DOCUMENT 009113.02 – ADDENDUM NO. 3

- A. Project Name: UMSL College of Optometry JC Penney North Renovation – Package 1
- B. Project Locations: 5 Arnold B Grobman Dr. St. Louis, MO 63121
- C. Owner: University of Missouri – St. Louis
- D. Architect: Cordogan Clark
- E. Architect Project Number: 234009
- F. Date of Addendum: November 19, 2024

3 BLDG. "A" LEVEL 7 - FLOOR PLAN
1-A2.11 1/8" = 1'-0"

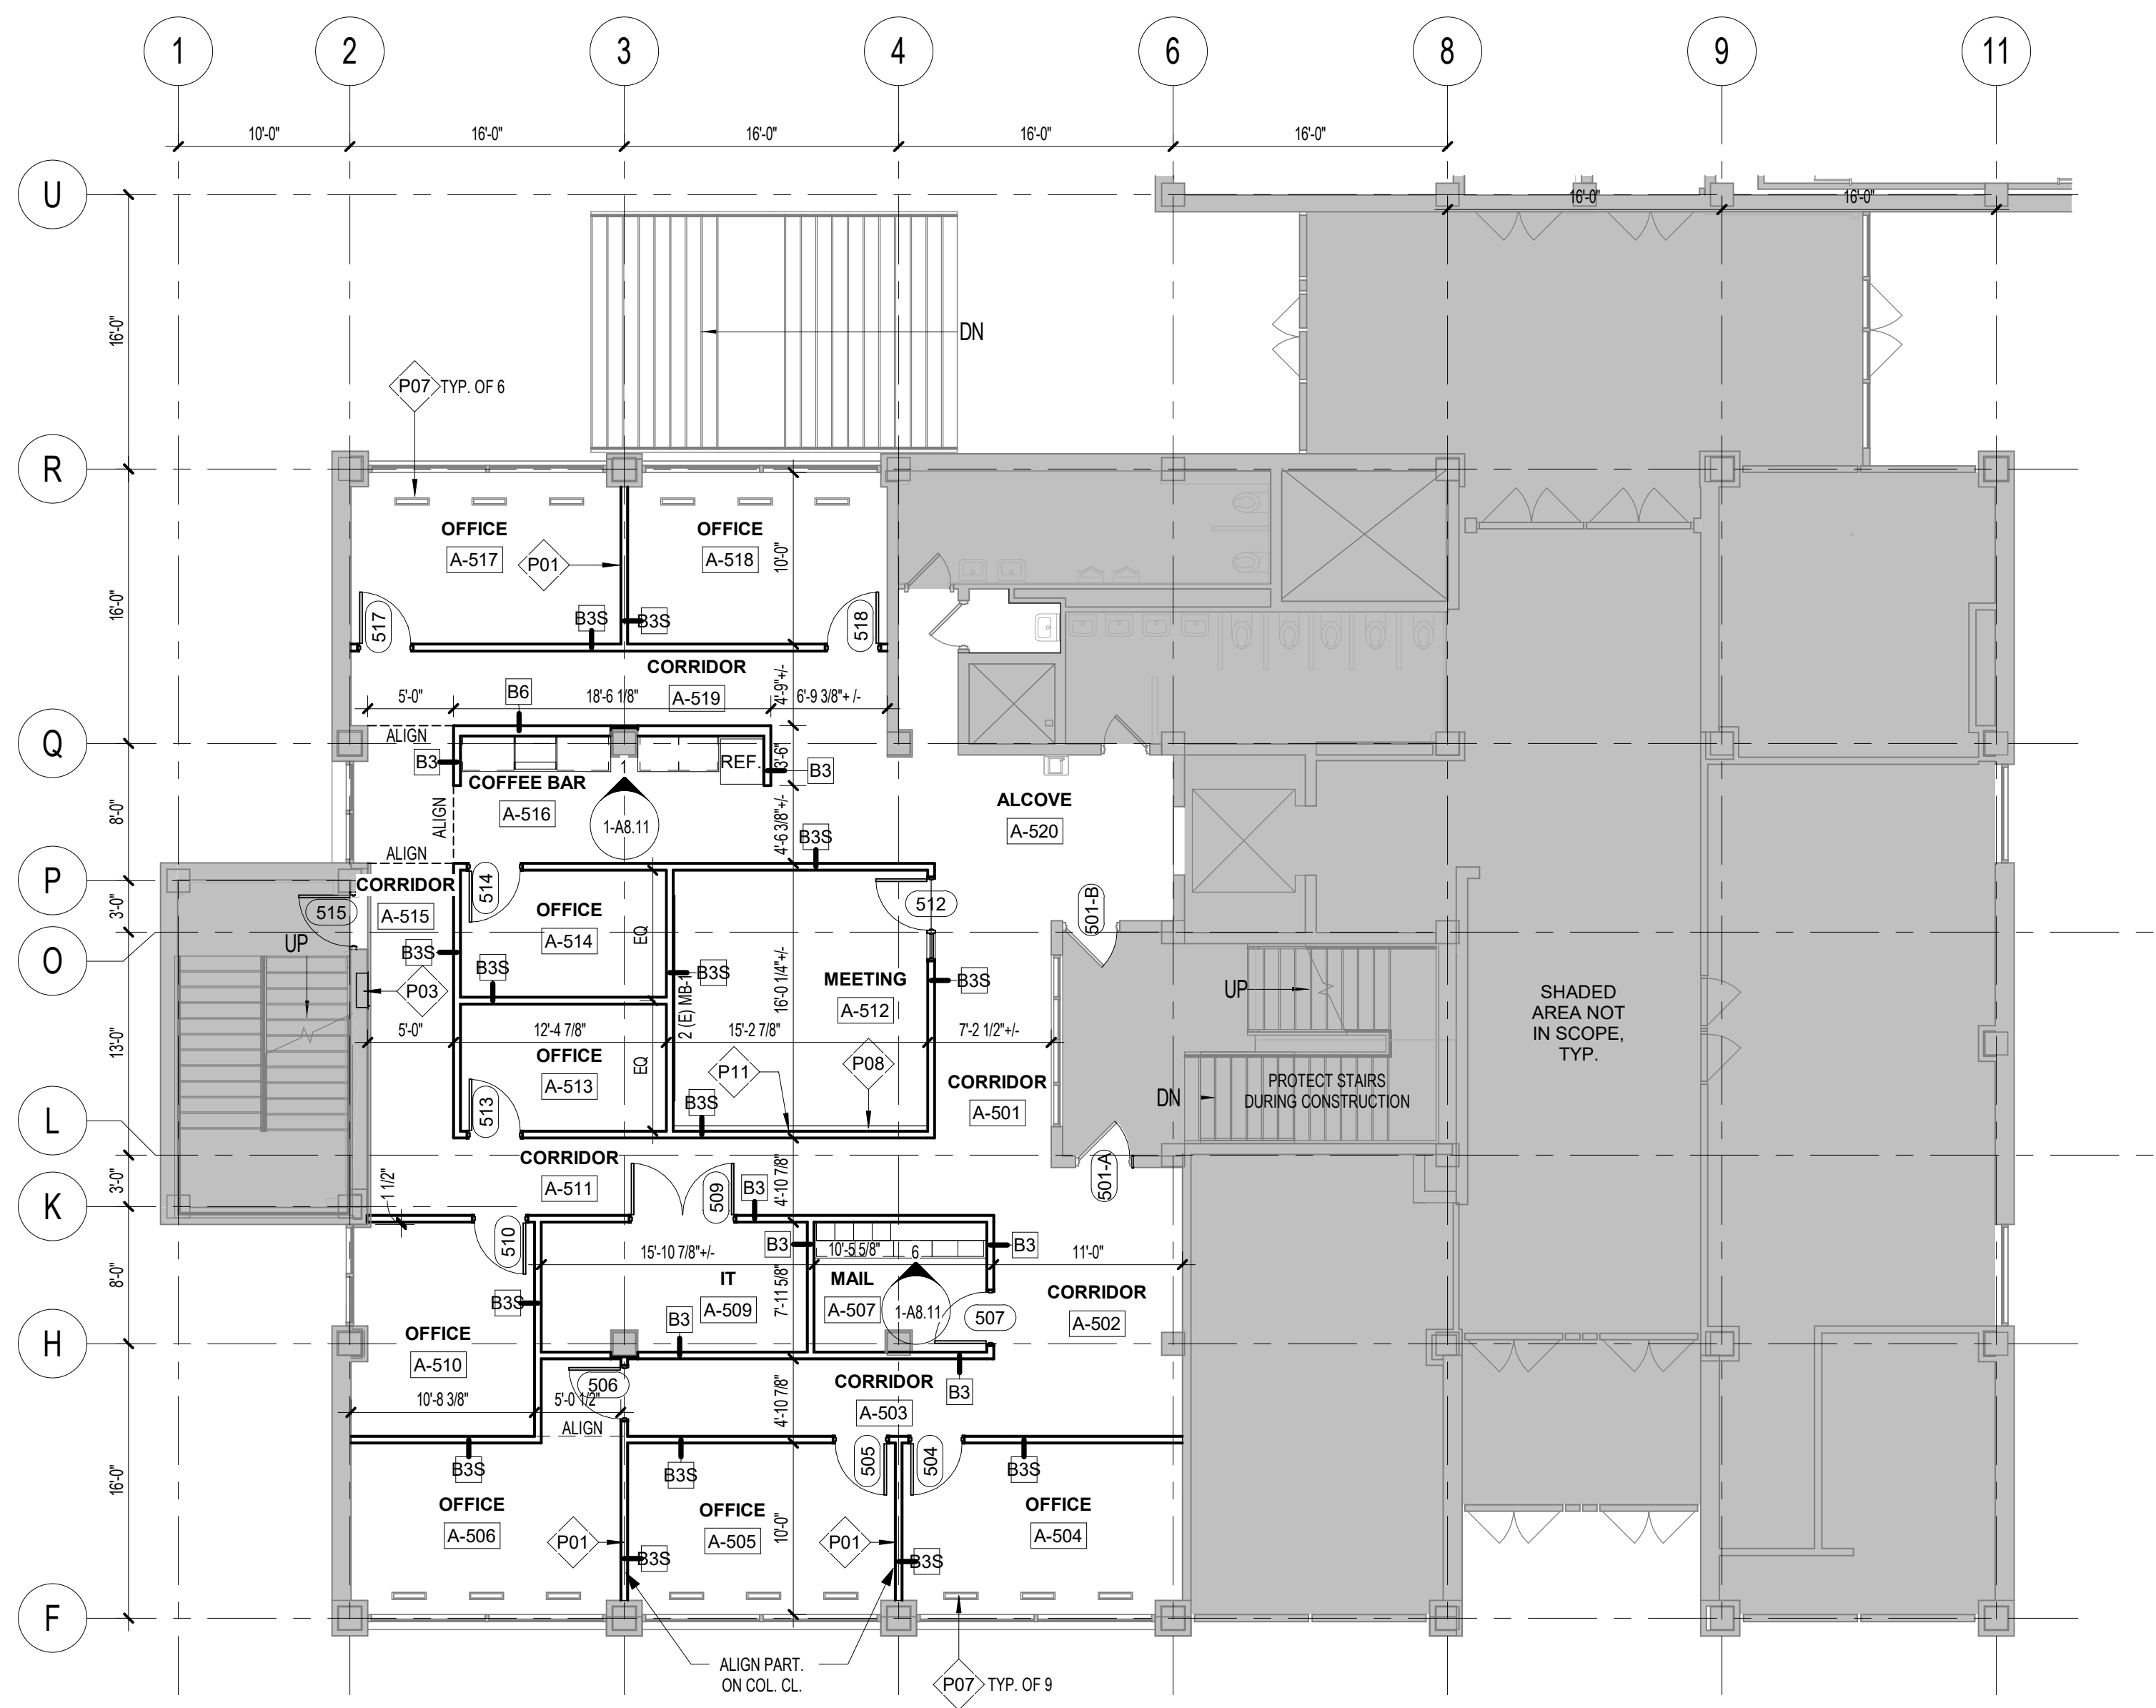
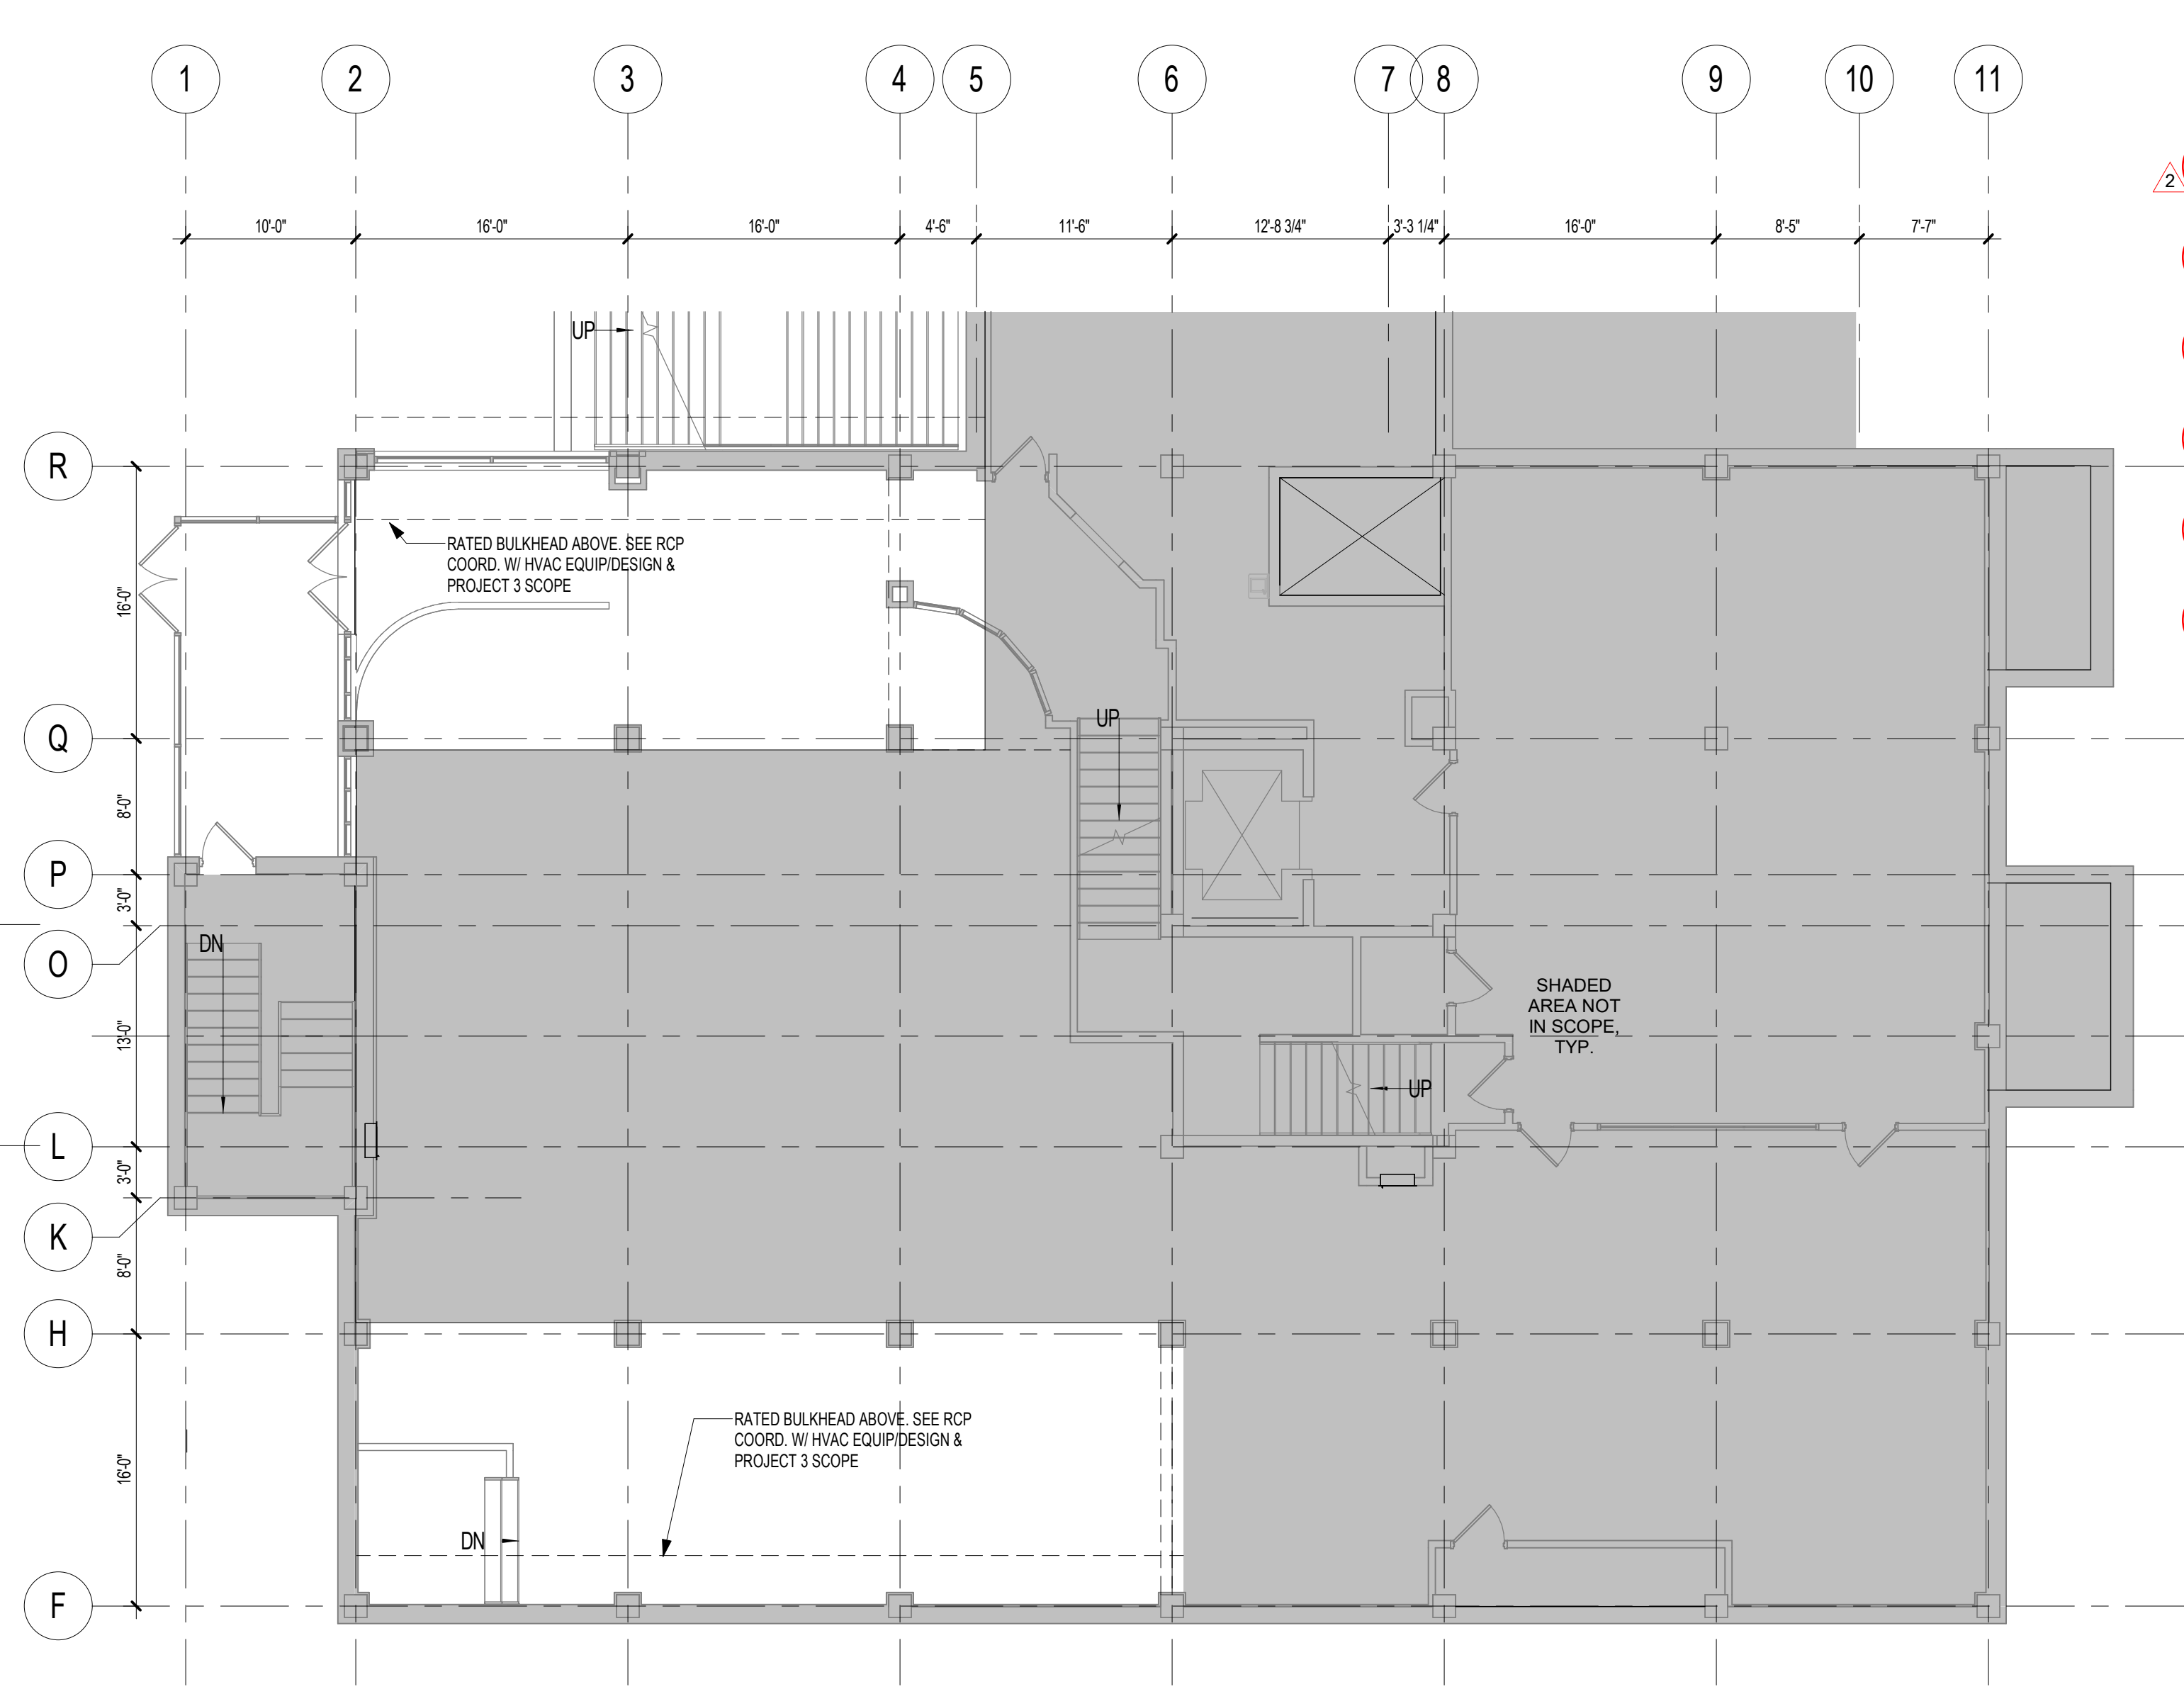
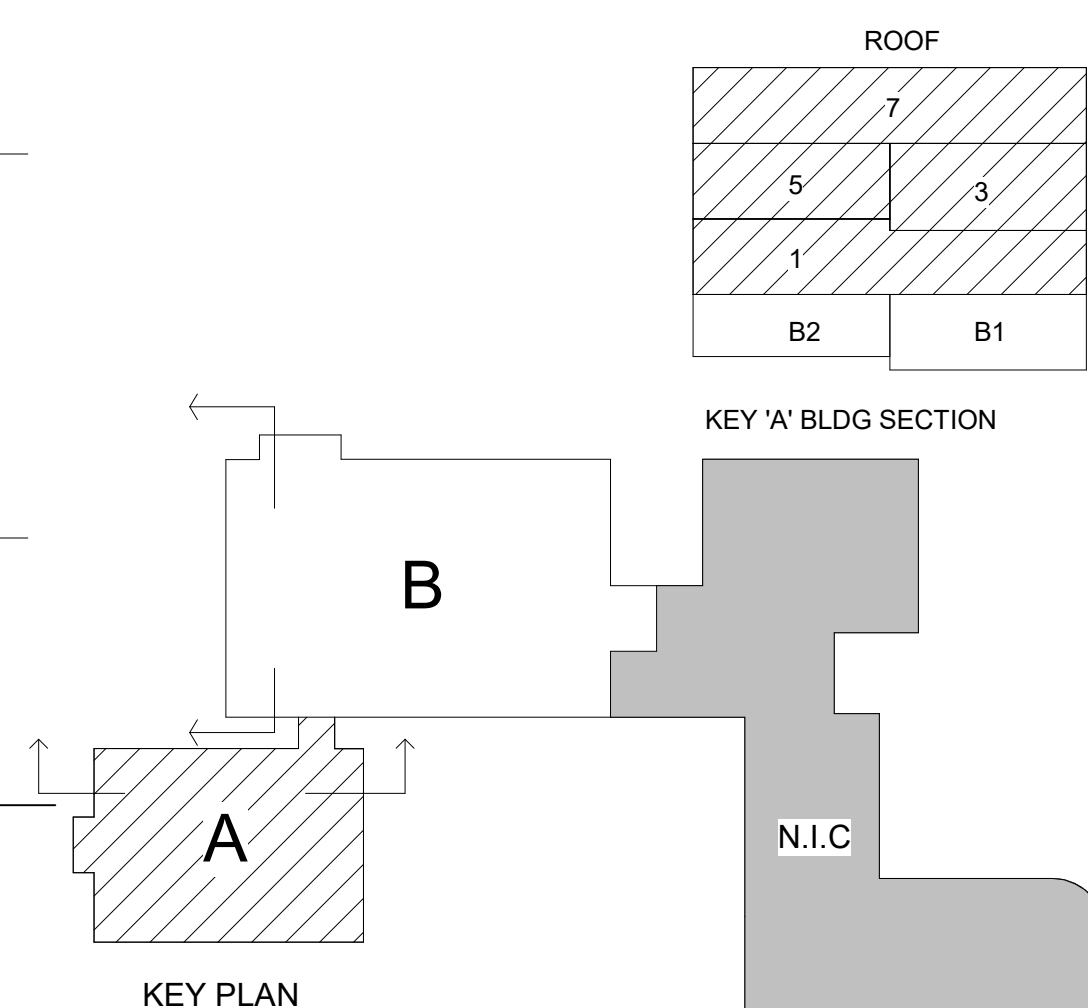
- A. Sheet 1-A2.11 (re-issued)
 - a. REVISE Appliance Schedule to include basis of design model numbers.

1 BLDG. "B" LEVEL 2 - FLOOR PLAN
1-A2.12 1/8" = 1'-0"

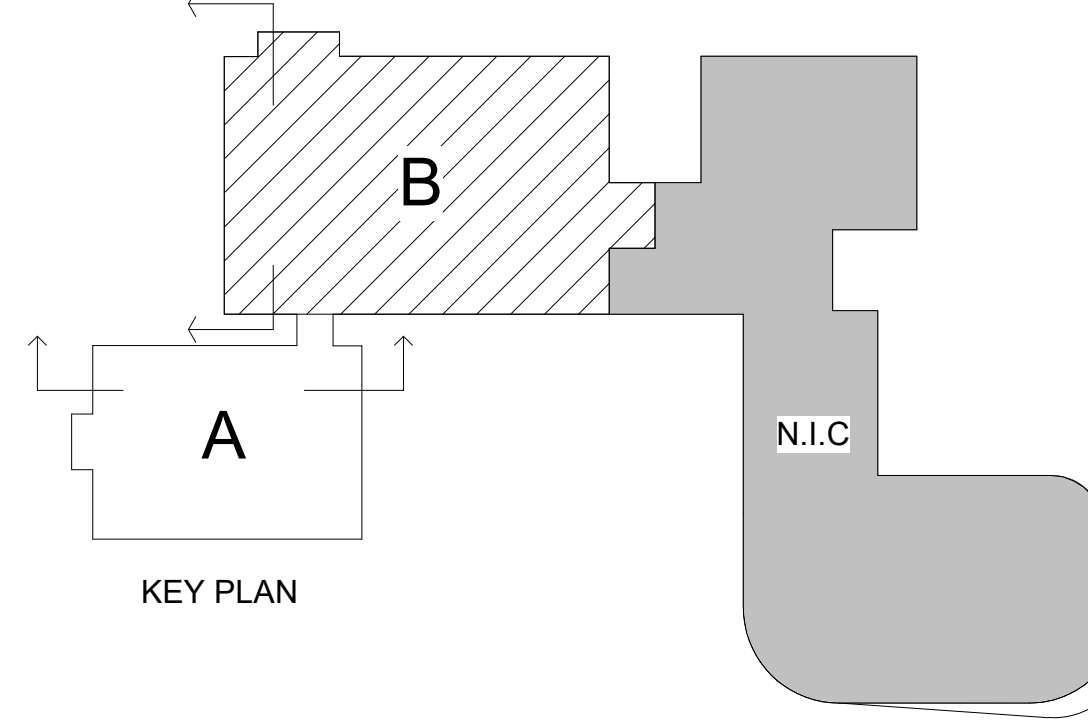
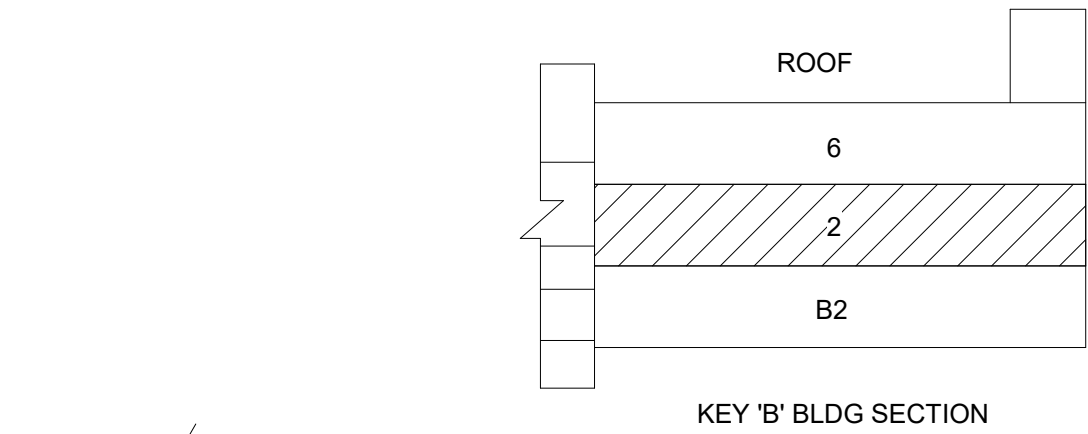
- B. Sheet 1-A2.12 (re-issued)
 - a. REVISE Appliance Schedule to include basis of design model numbers.
